# **Baldwin Planning Board**

## **Meeting Minutes**

### **I. Public Hearing – D&D Oil Bulk Oil Storage Facility**

Re: Supplemental Submission  
Proposed Bulk Oil Storage Facility  
D&D Oil  
Route 113, West Baldwin, Maine  
St.Germain Collins File No.: 4076

OVERALL SITE PLAN

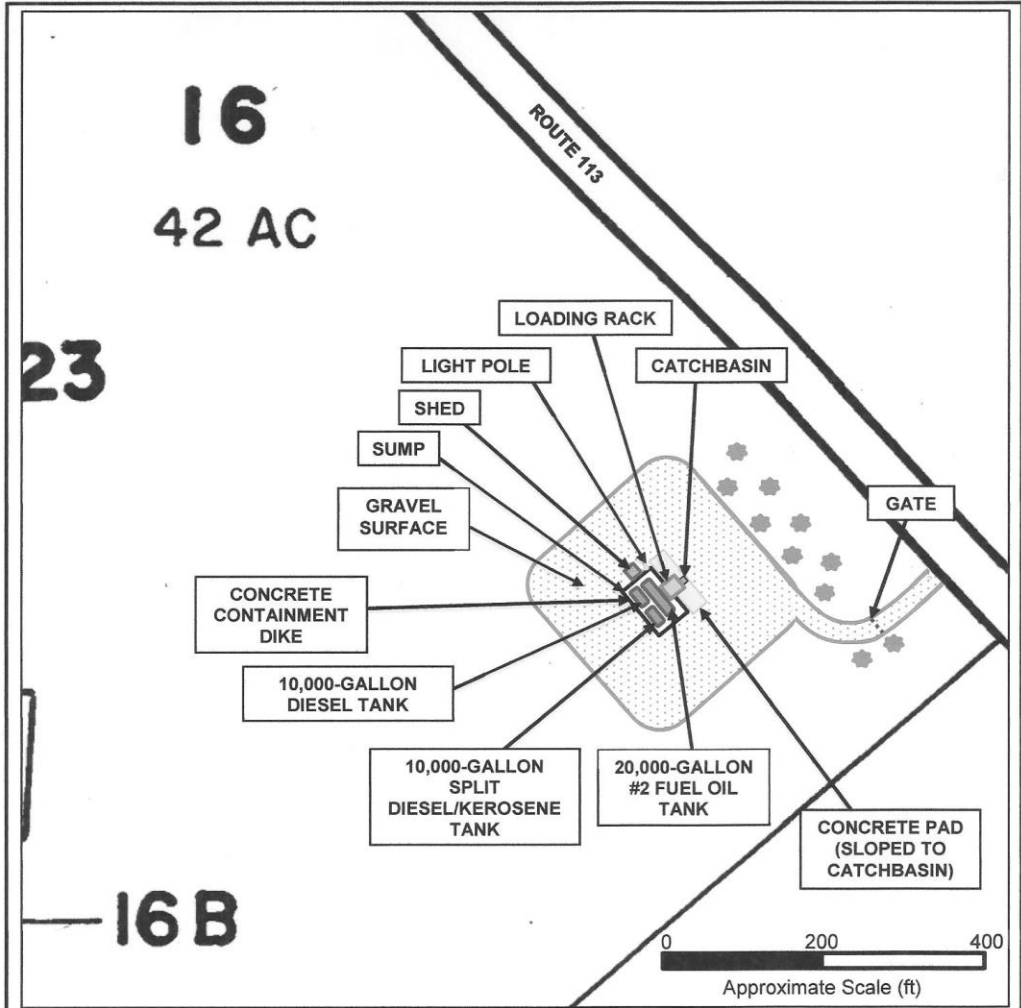
- Norm asked about the white pines planned for vegetative screening. The plans (attached) show a sufficient number of white pines approximately 6' tall planted in front of the bulk fuel storage facility. Norm requested that D&D Oil maintain the vegetative screening should any of the pines die after planting.

- N.B. East Gate post to SE corner – clear out that triangle.
  - Plant and maintain a double-staggered row of  $\geq 6$  foot white pines as a visual barrier between the facility and the road.

St. Germain • Collins **FIGURE 4**

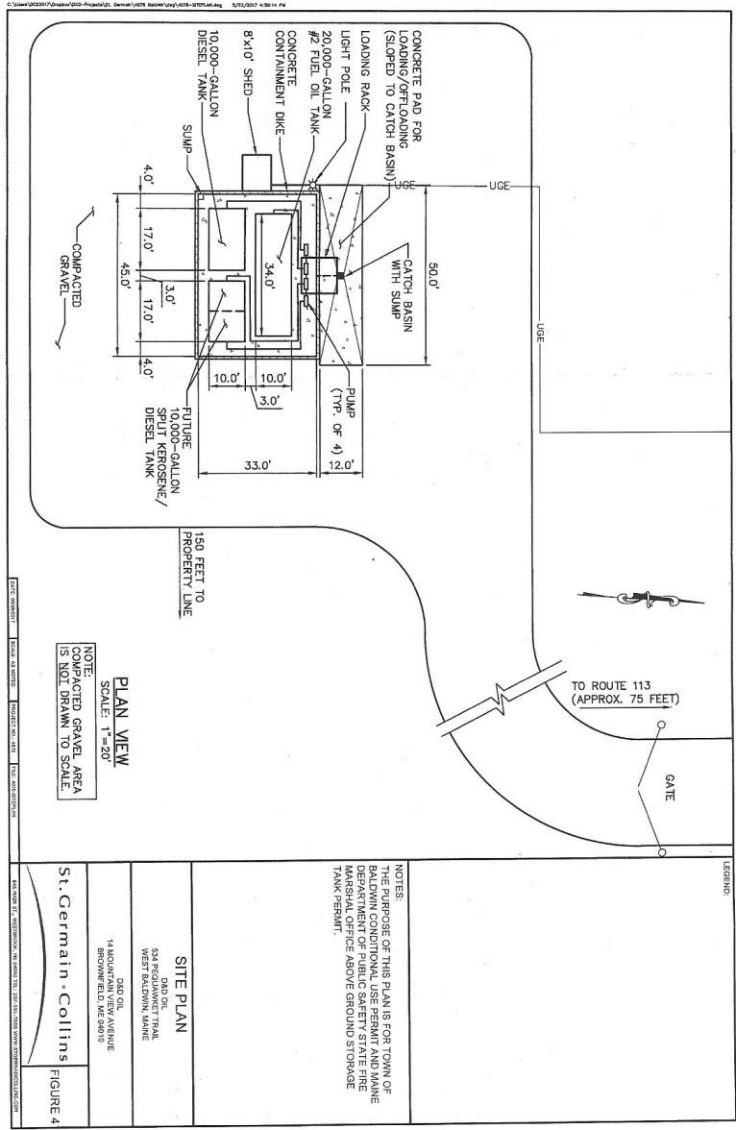
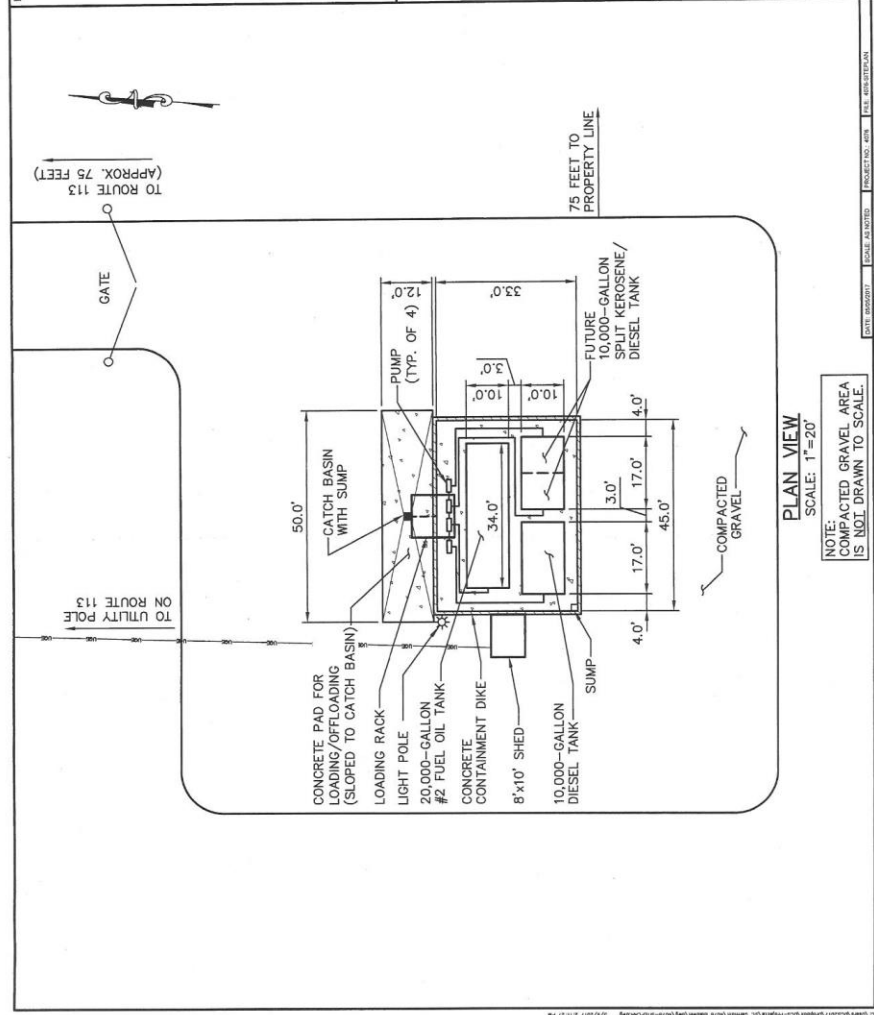
1. Can a Site Plan be provided with more detail? *Figure 4 is enclosed.*
2. Can shed location be shown on Site Plan? *Shed shown on Figure 4.*
3. Will trucks be parked at the facility? *Yes, there is a possibility that up to two delivery trucks will be parked at the facility during nighttime hours.*

7. Can a low-intensity light be installed? *One pole light will be installed, see Figure 4 and enclosed cut sheet for proposed pole-mounted light (or similar equivalent).*
